Streets People Love Hobart

Submission to the Inquiry into the
Macquarie Point Northern Access Road
by the Parliament of Tasmania Public
Works Committee

2nd February 2026

Figure 1 – Examples of intersections needing safer design. In particular, the proposed alignment of the port access road would likely encourage excessive speed through the pedestrian crossing point.

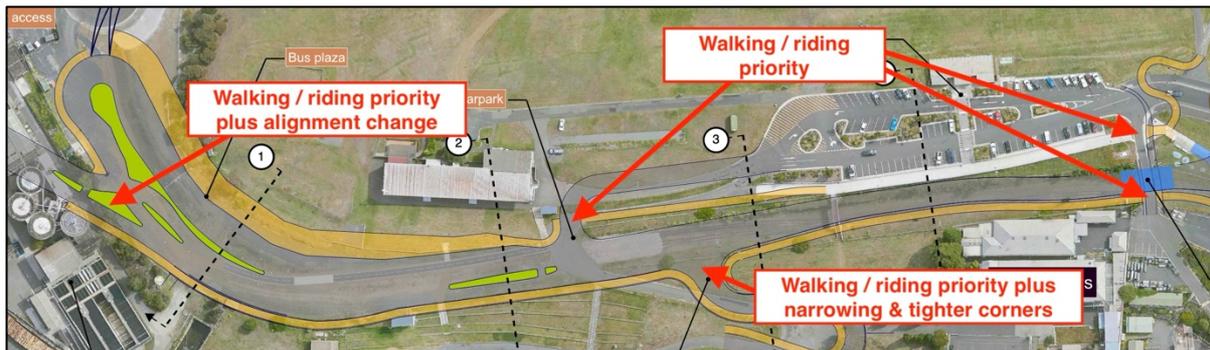
1. Incorporating intersections that are safer for people walking and riding (Figure 1), such as by:
 1. Prioritising walking and cycling when crossing side streets using designs like continuous footpaths and raised pedestrian crossings.
 2. Narrowing intersections and tightening corners to slow vehicles.

Figure 3 – Example of a path which appears too narrow for stadium crowds and which is located immediately adjacent to the road.

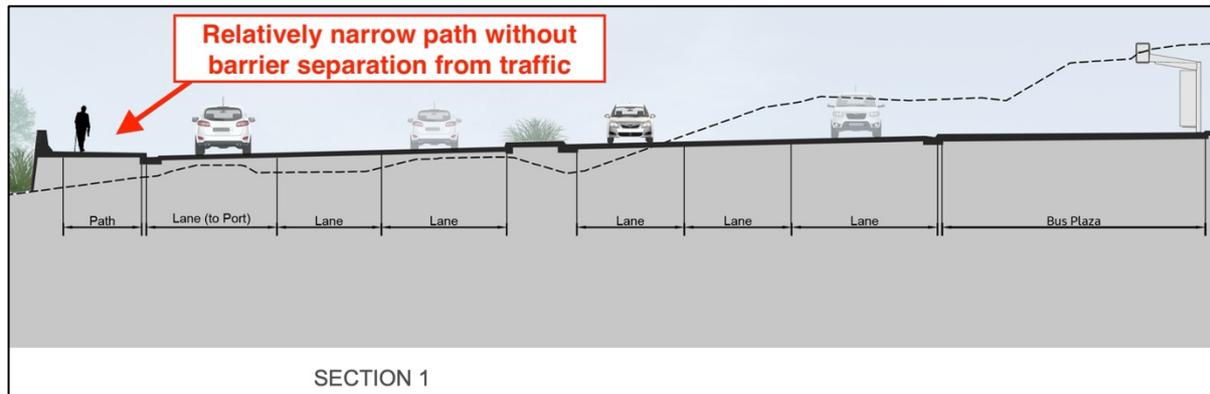
4. Ensuring paths are wide enough to meet peak volumes during crowd dispersal after stadium events (Figure 3). This is important to avoid people spilling onto the access road and minimise the risk of collisions between pedestrians and event buses.

Figure 4 – An example of importance of providing paths where people want to go, in this case to allow travel directly from the stadium to the proposed ferry terminal.

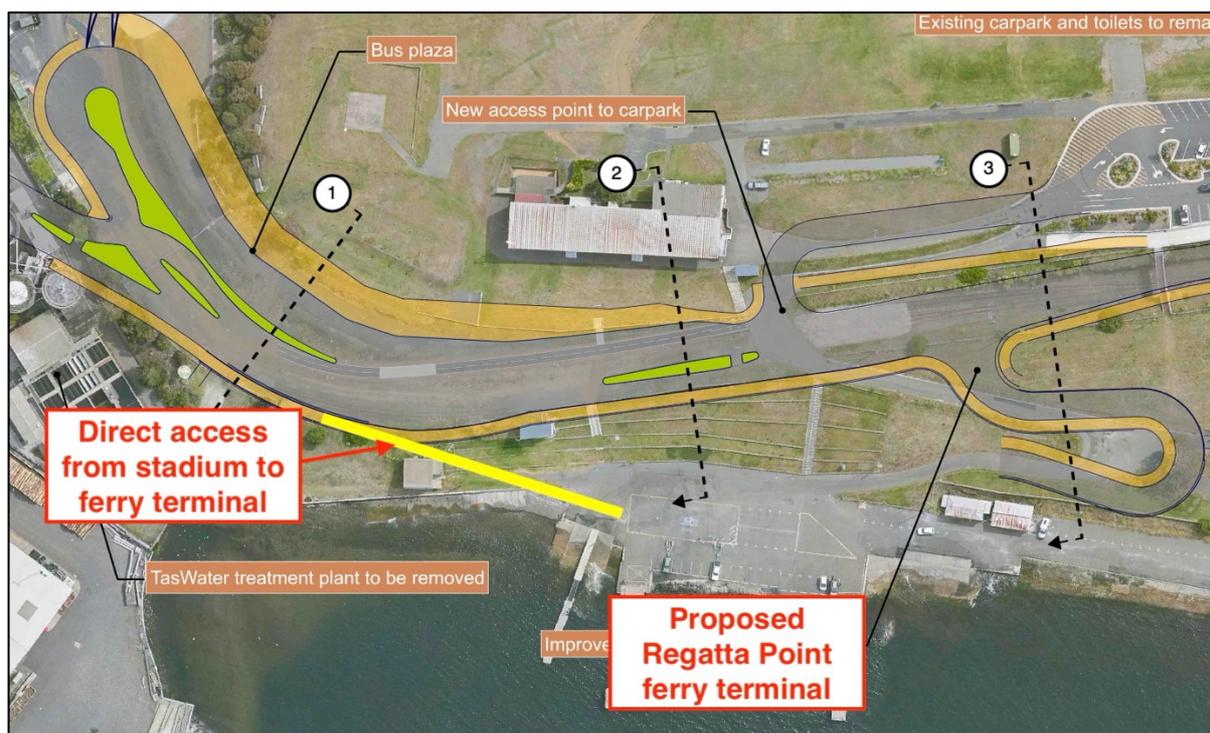
5. Ensuring walking and riding paths go where people want to go, not just where it is easiest to build (Figure 4 & Figure 5). If the paths are not direct enough, and there are no physical barriers, pedestrians are likely to ignore the paved infrastructure and create new desire-lines, intersecting roads and mixing with cars and buses in a dangerous manner, especially in high-volume times such as during stadium events.

Figure 5 – A second example of providing paths where people want to go, in this case directly from the Intercity Cycleway towards the Domain. Demand here is clear even from space by the desire-lines formed by people repeatedly taking a shortcut across the grass.

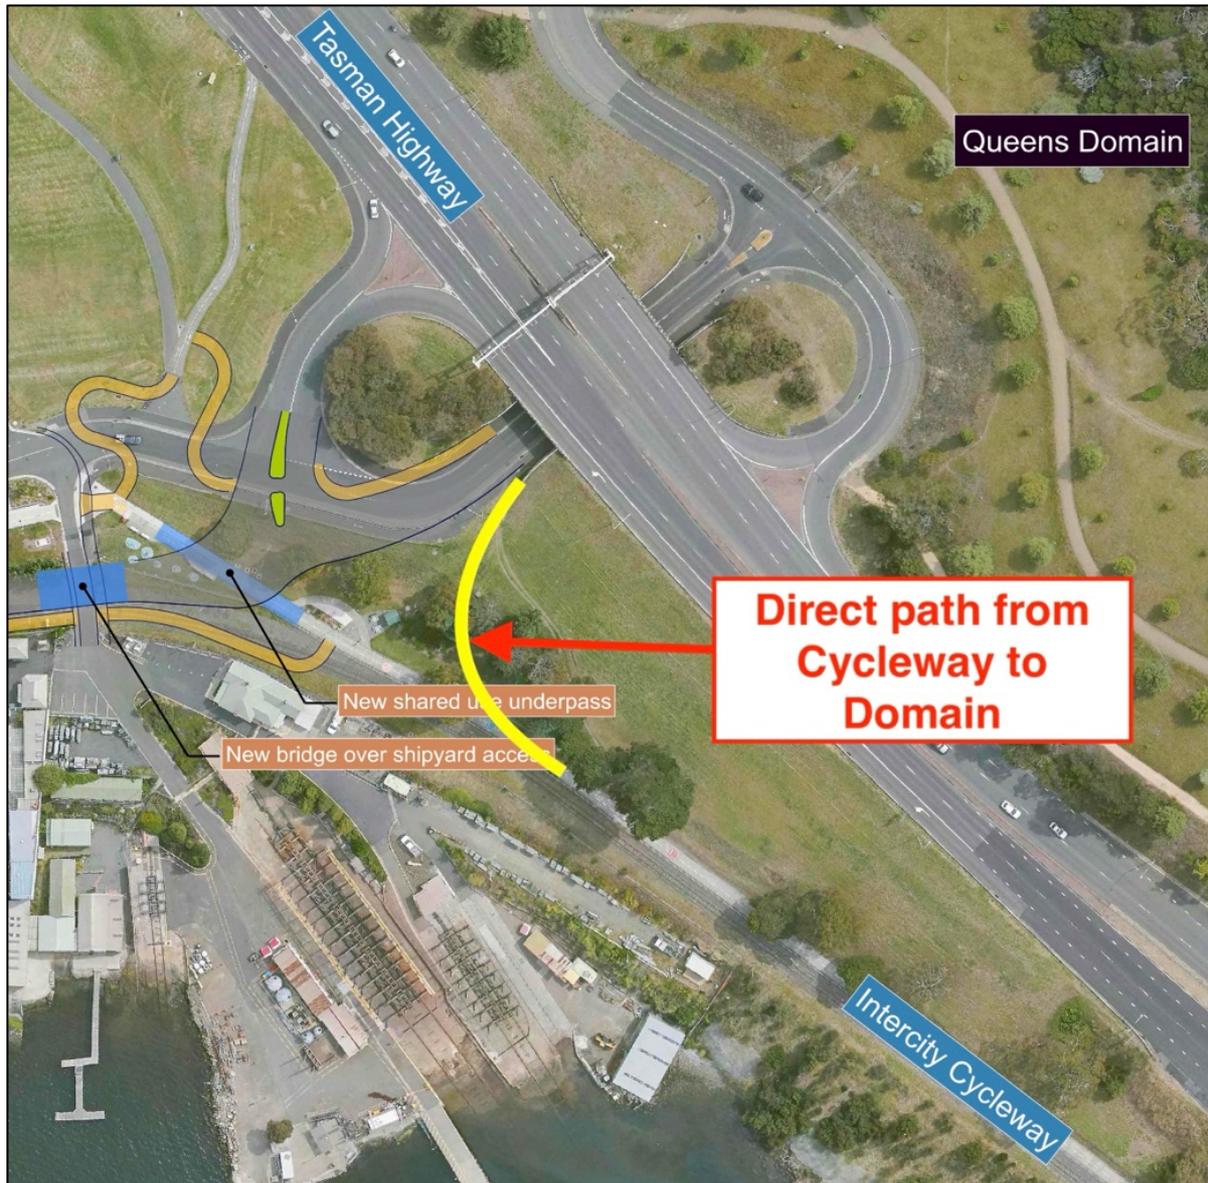
6. Ensuring the project scope includes improvements to the movement of people walking and riding throughout the area (Figure 5).

Figure 5.5 — From “Austroads Guide to Road Design Part 6A: Paths for Walking and Cycling”. Path widths for a 75/25 directional split (e.g. stadium ingress/egress). Where the path widths are shown for a bicycle path and a pedestrian (footpath) path together, these are separated paths.

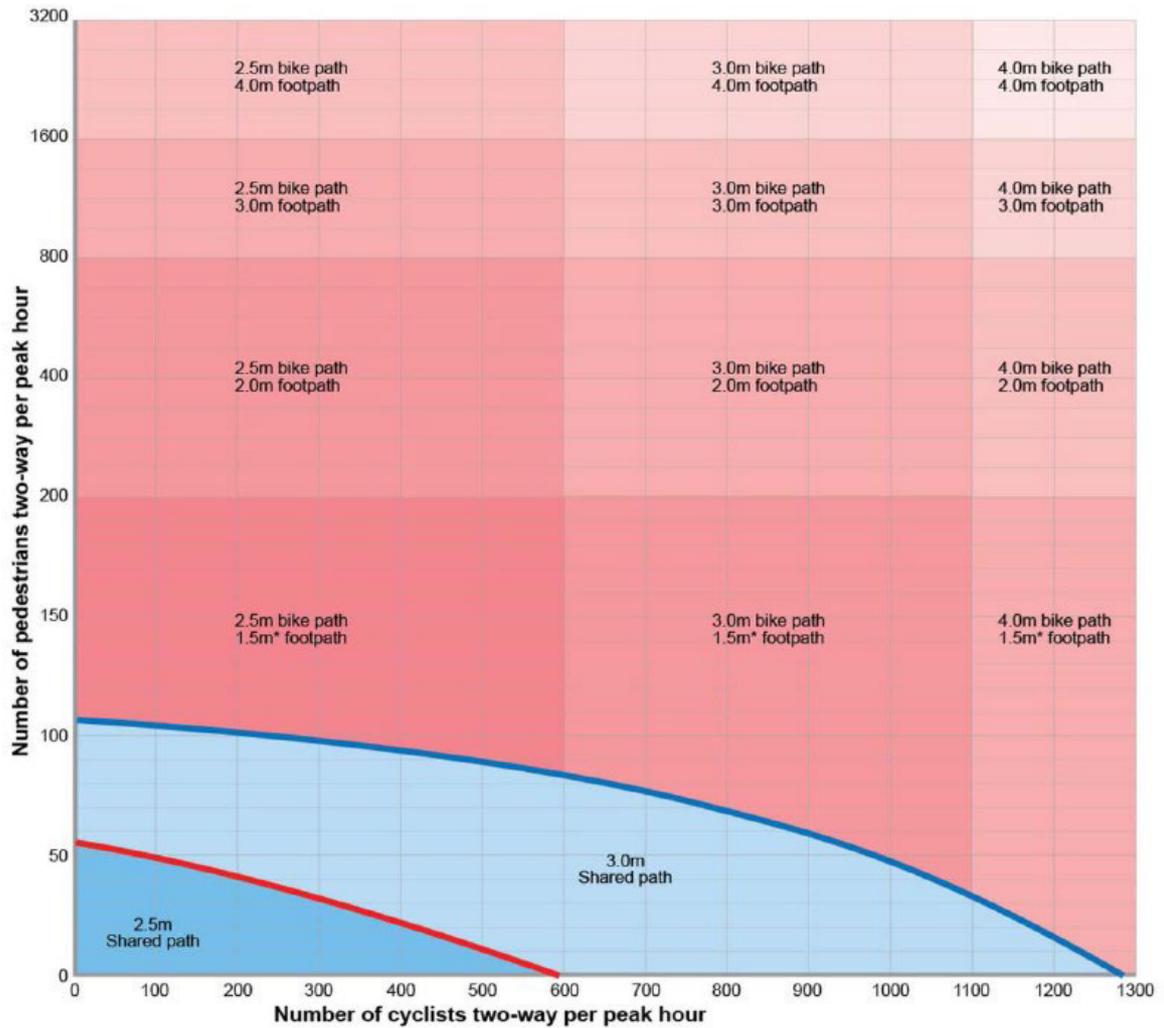
2. Providing separated paths for people walking and people riding (Figure 2). Shared paths are not appropriate for high volumes — Australian guidelines suggest separation at more than 100 pedestrians per peak hour, which these paths will easily exceed (Austroads 2021).
3. Ensuring cycle paths are at an appropriate incline and curvature, and that they intersect with roads and other paths at appropriate angles for cyclists to travel safely and efficiently, with clear line-of-sight.

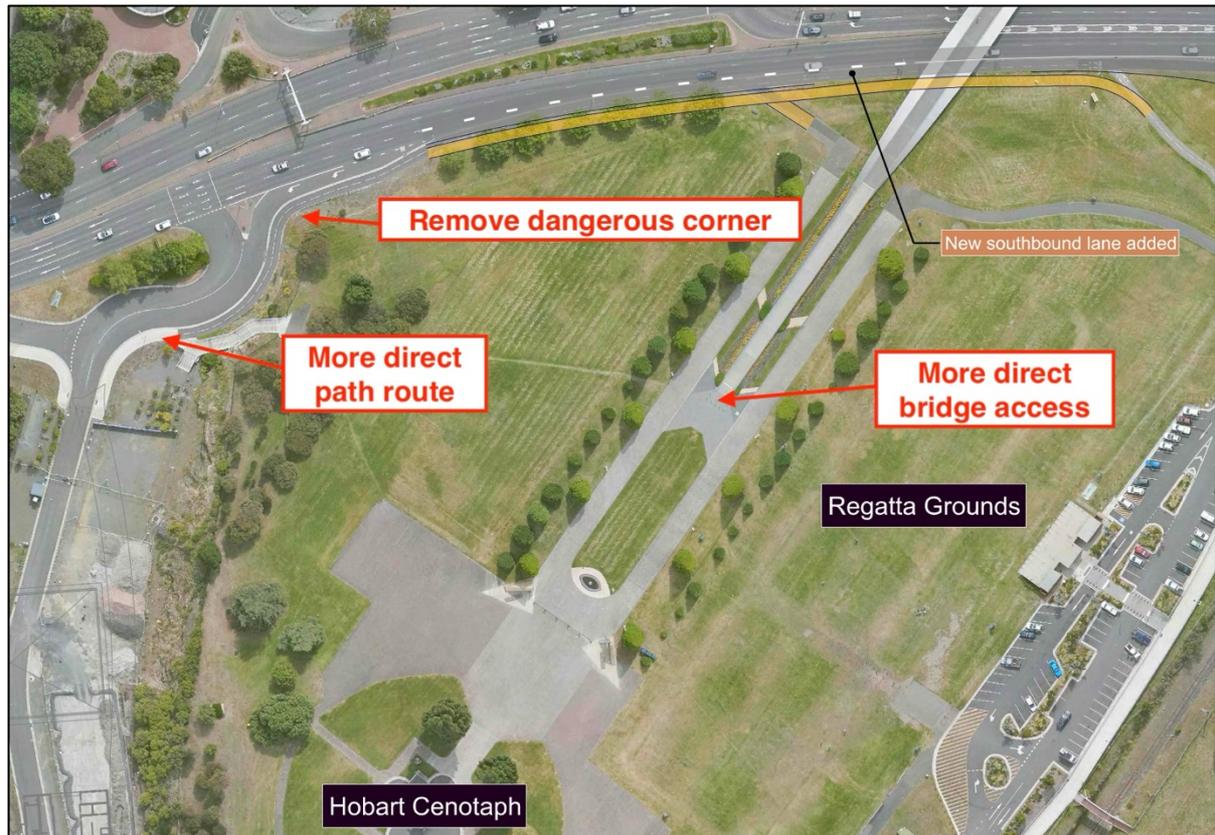
Figure 6 – Examples of potential improvements to walking and riding within the area of works. These particular changes could be achieved with a rerouted shared or separated path(s) – appropriate to incorporate into the construction of the additional southbound lane and likely to simplify traffic management during that project.
